# **EEE deep sleep capability with XLAUI and CAUI (comment #110)**

Adam Healey, LSI Corporation

IEEE P802.3bj Task Force

July 2013

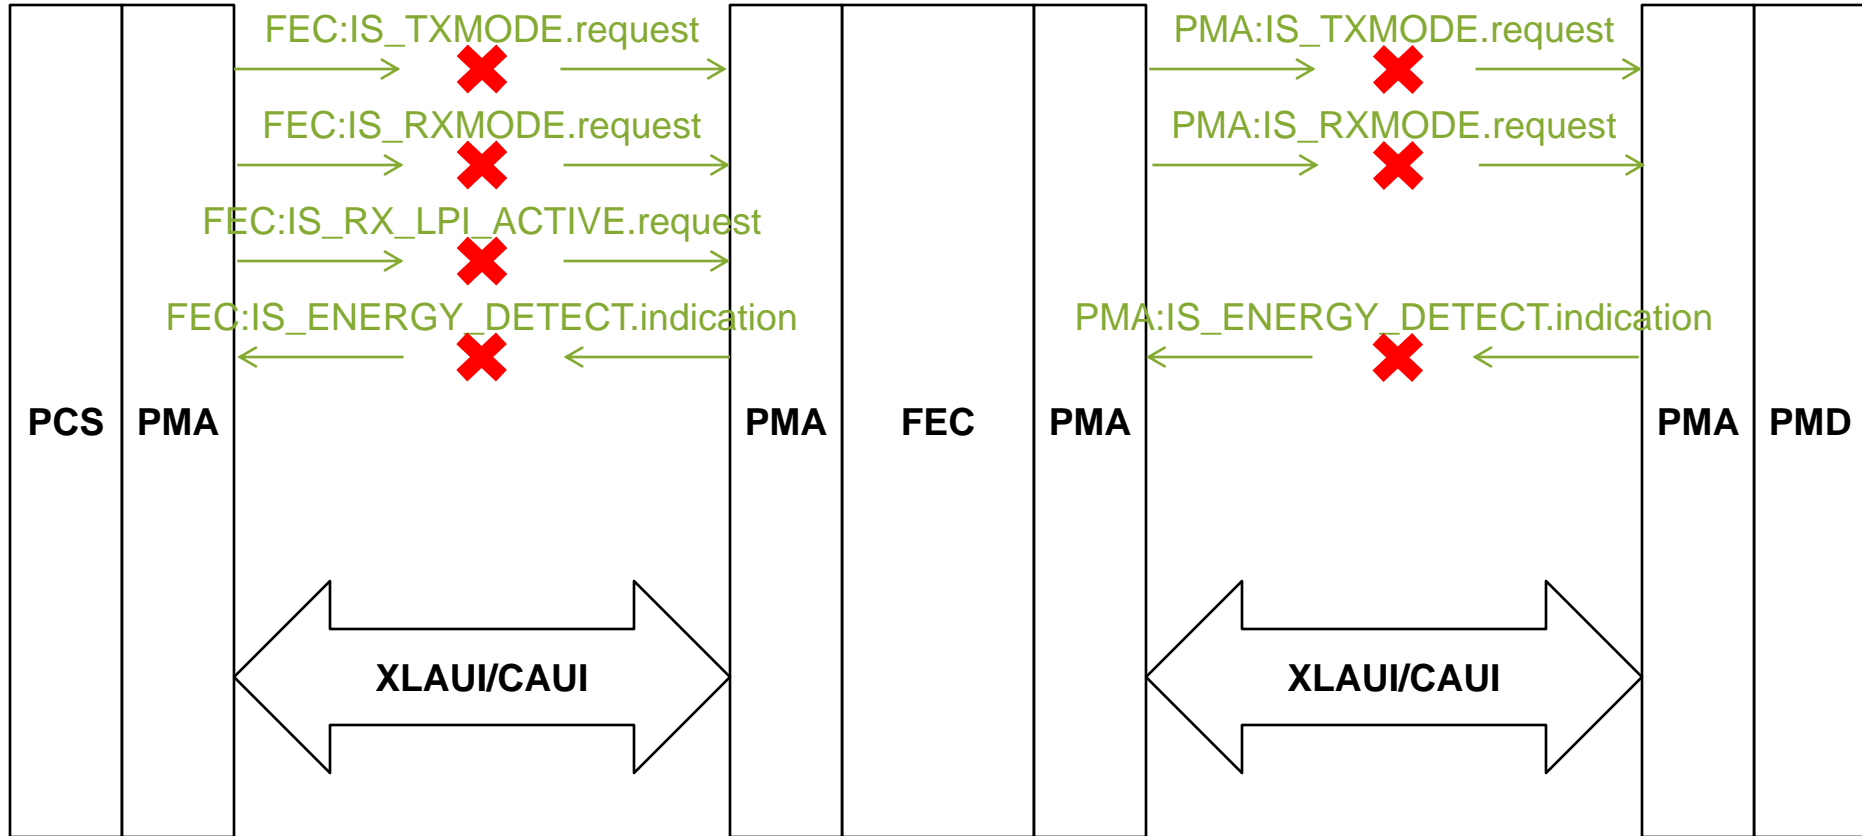
**XLAUI or CAUI does not provide a means to communicate the primitives required for correct operation of the optional EEE deep sleep capability**

**Figure 83–YY—** Scrambler for PMA quiet and alert signals

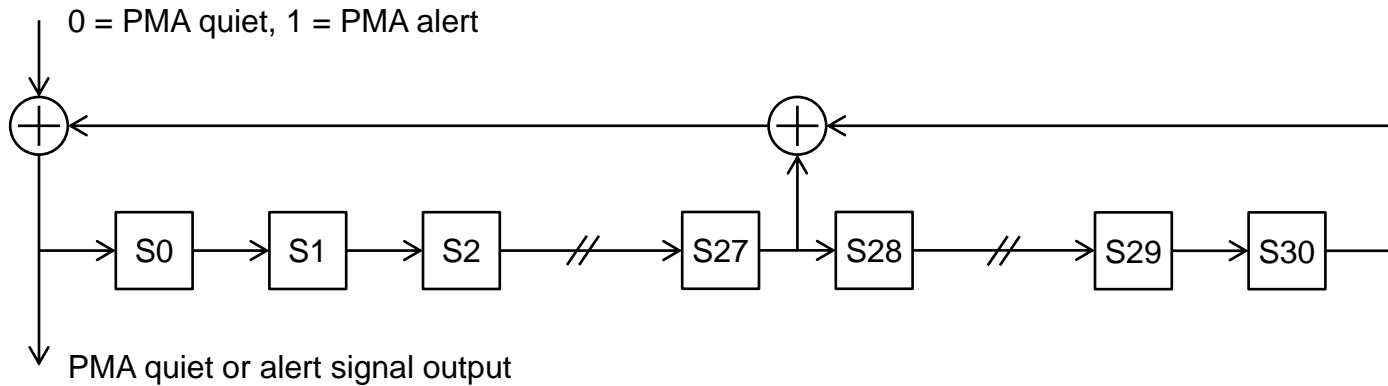
The PMA quiet and alert signals are generated on each lane with a self-synchronizing scrambler. The scrambler shall produce the same result as the implementation shown in Figure 83–XX. This implements the scrambler polynomial defined by Equation (83–YY).

To generate the PMA quiet signal the input to the scrambler shall be 0. To generate the PMA alert signal the input to the scrambler shall be 1.

The initial state the scrambler of a given lane of PMA service interface is chosen to minimize the correlation between lanes.

**Figure 83–ZZ —** Decrambler for PMA quiet and alert signals

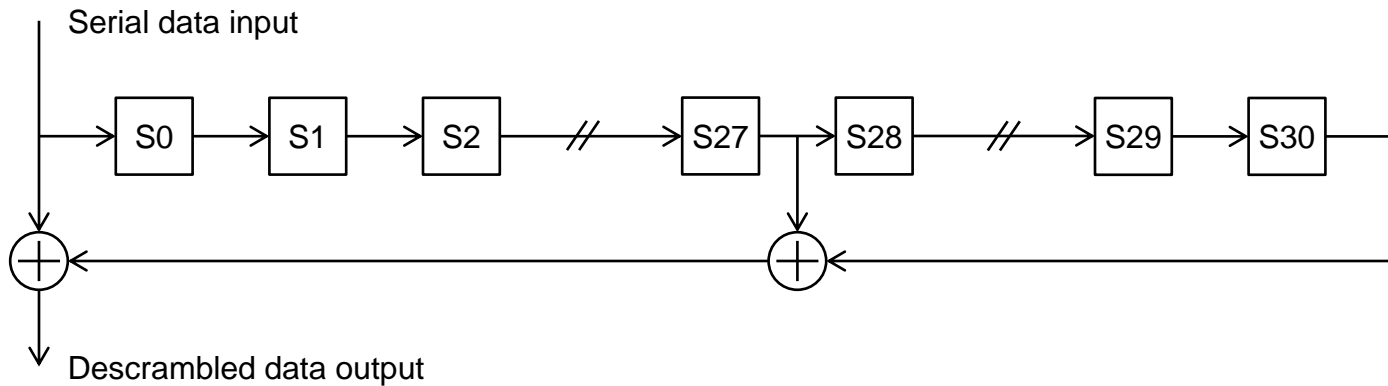
Each lane detects the PMA quiet and alert signals at the output of a self-synchronizing descrambler that implements the polynomial defined in Equation (83–YY). The descrambler shall produce the same result as the implementation shown in Figure 83–ZZ.

The output of the descrambler is considered in consecutive, non-overlapping blocks of 256 bits. If the number of zeros detected in a given 256-bit block is greater than or equal 224, then the lane shall indicate that the PMA quiet signal is detected. If the number of ones detected in a given block is greater than or equal to 224, then the lane shall indicate that the PMA alert signal has been detected. Otherwise, the lane infers that normal data is being received and shall not indicate that either the PMA quiet or PMA alert signal has been detected.

The PMA shall indicate that the quiet signal is detected when all lanes of the PMA service interface have detected the quiet signal. The PMA shall indicate that the alert signal is detected when all lanes of the PMA service interface have detected the alert signal. Otherwise, the PMA infers that normal data is being received and shall not indicate that either the PMA quiet or PMA alert signal has been detected.

# Proposed changes to Clause 94

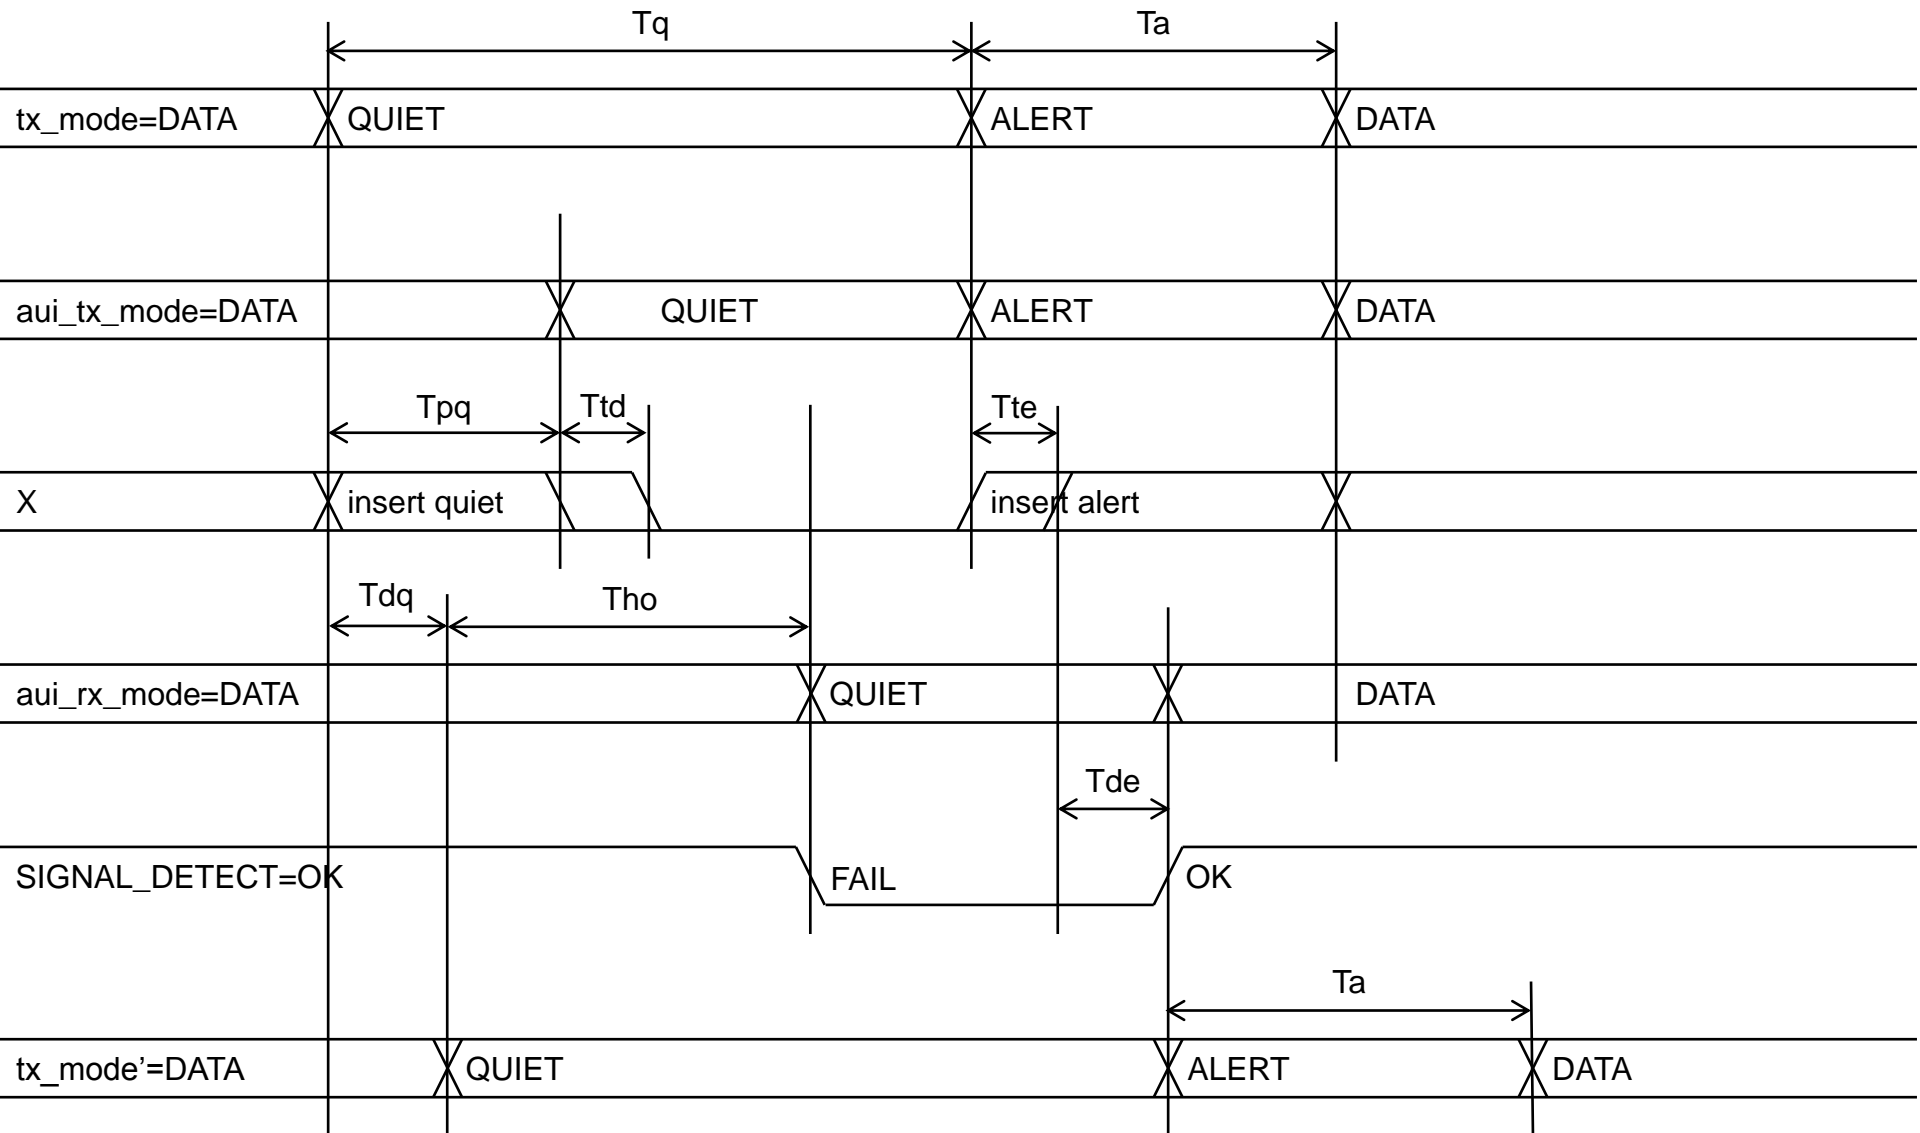
Clause 94 includes the definition of a PMA sublayer that is specific to 100GBASE-KP4 and the proposed changes to Clause 83 do not apply.

However, the service interface must include the PMA:IS\_RX\_TX\_MODE.indication primitive and the value of rx\_tx\_mode must be defined. This will be passed through the RS-FEC sublayer to enable the CAUI implementation that could exist above.
